Post-Exhibition Report – PP-2022-1748

The planning proposal seeks to include the ‘Cooks Cove’ site within the Bayside Local Environmental Plan 2021 and rezone the land for the purpose of commercial and trade related enterprises, hotel or motel accommodation, serviced apartments and public open space.

Figure 3. Existing zoning on the left (source: EHC SEPP, Chapter 6 Cooks Cove) and proponent proposed zoning (right) (March 2024)

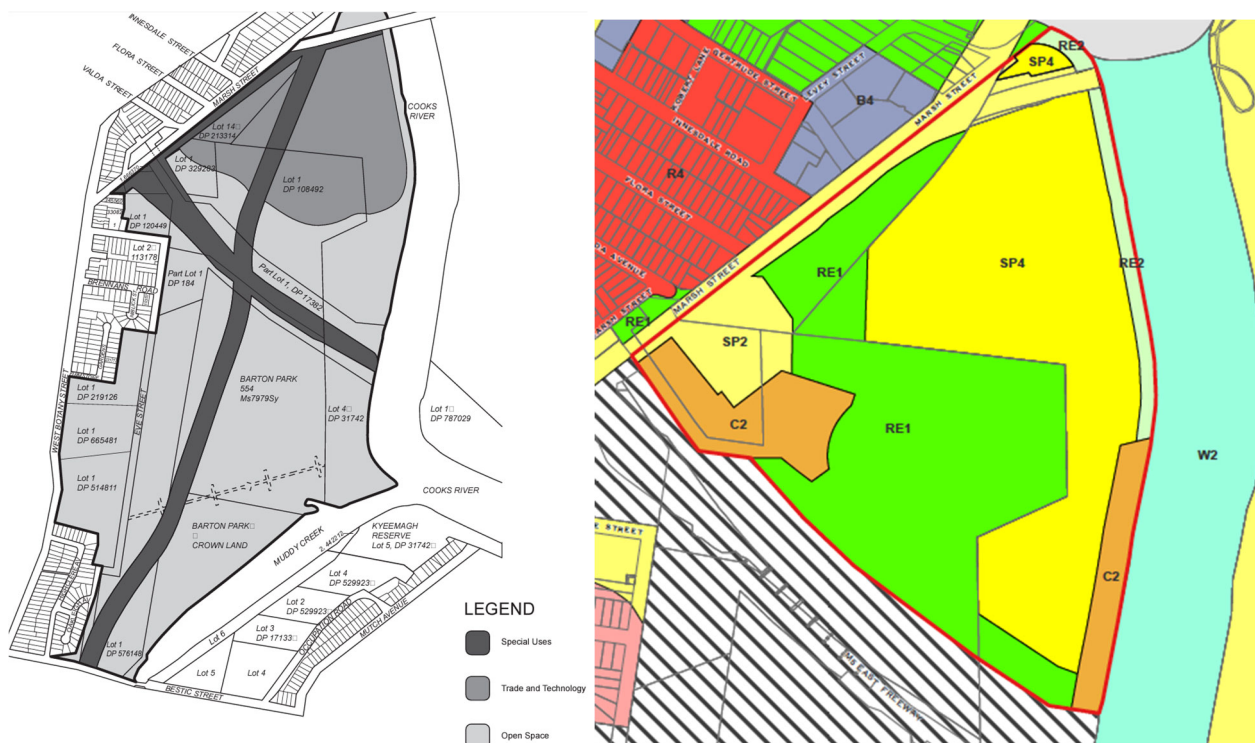
DPHI's zoning recommendation is to retain the C2 the full length of the site's interface with Cooks River as per the figure below. This is to ensure that the intended conservation use of the land occurs the full length of the Cooks River, consistent with the requests from Council and the NSW Department of Climate Change, Energy and the Environment (DCCEEW). The use of the C2 zone the full length will ensure enable the protection and enhancement of the riparian corridor and its ongoing use for walking, cycling, environmental protection and passive recreation.

Additionally, the RE2 zone in the Bayside LEP 2021 permits uses including entertainment facilities, information and education facilities, kiosks, places of public workshop, recreation facilities (indoor, and major) registered clubs and respite day centres, which are not appropriate for the subject land.

Figure 8: Proposed Design Excellence Map (post-exhibition change) (source: Planning Proposal, September 2023)

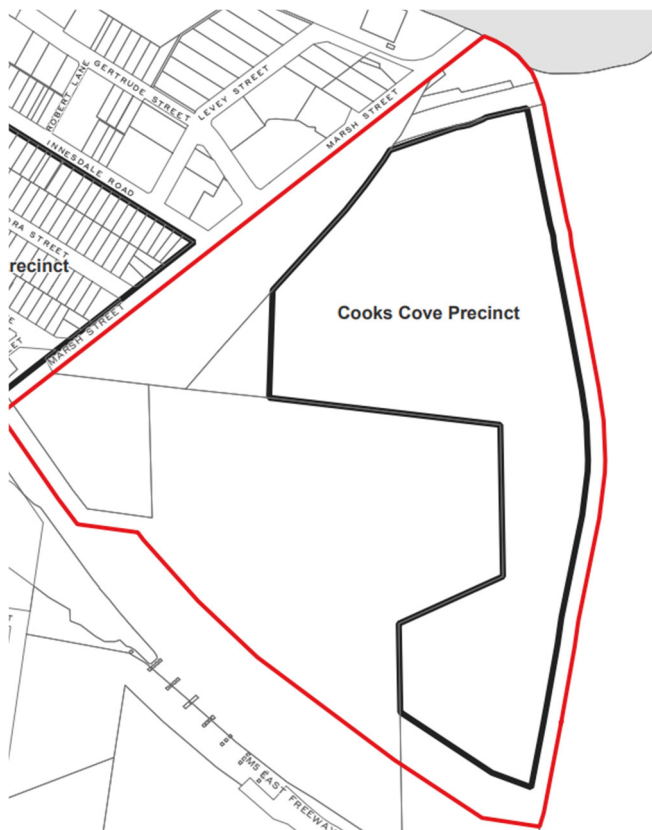
Agile Planning is also recommending extending the application of Design Excellence (Clause 6.10 in the Bayside LEP 2021) to include the smaller portion of land to the north of Marsh Street. This land is proposed to have a building height of 24 metres, and the application of the Clause would only require consideration of a future development application by a Design Review Panel. No competition would be required.

Figure 9: Proposed Zoning and Additional Permitted Uses maps (post-exhibition change) (source: Agile Planning, DPHI, February 2024)

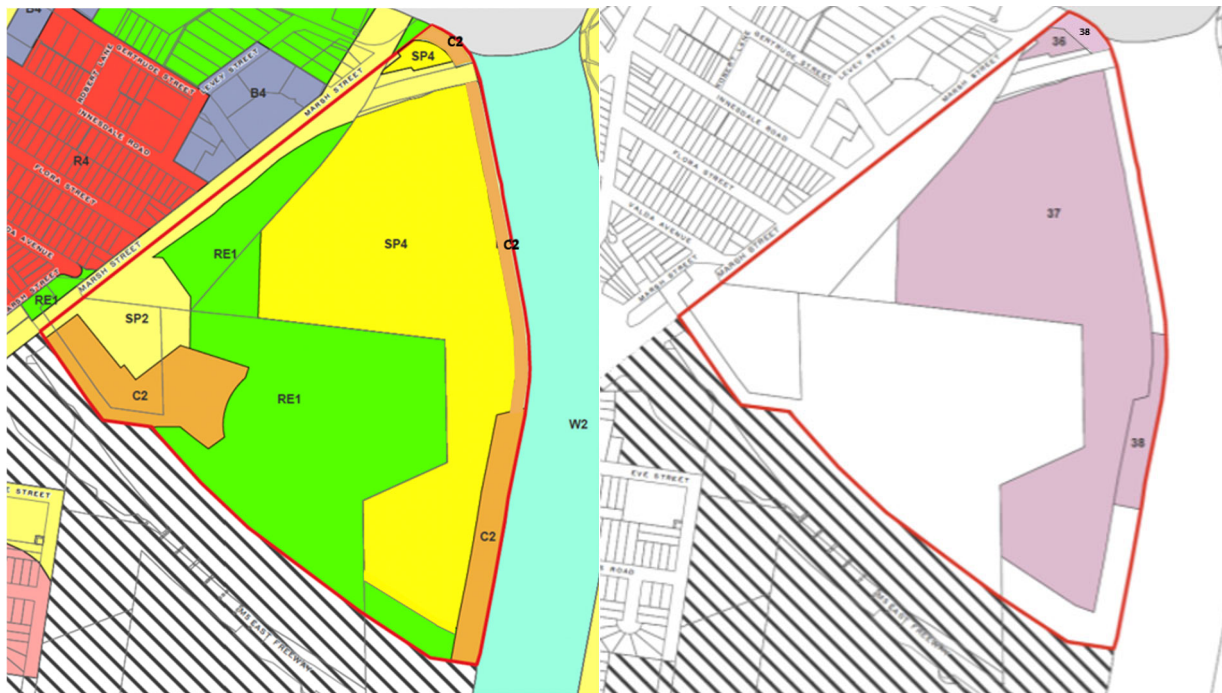
The only substantive recommendation from Agile Planning that is not strictly consistent with the post-exhibition proponent proposal relates to the extent of the C2 Conservation zone. Agile Planning is of the view that appropriate protection and rehabilitation of the riparian corridor adjacent to Cooks River will occur best through the C2 zoning, which will ensure the full river corridor benefits. It is acknowledged that in the northern portion of the site adjacent the river, part of the existing road network is located with the C2 zone sits. Agile Planning's recommendation to resolve this matter, is to simply extend the 'Area 38' additional permitted use of 'roads' to also apply to this area.
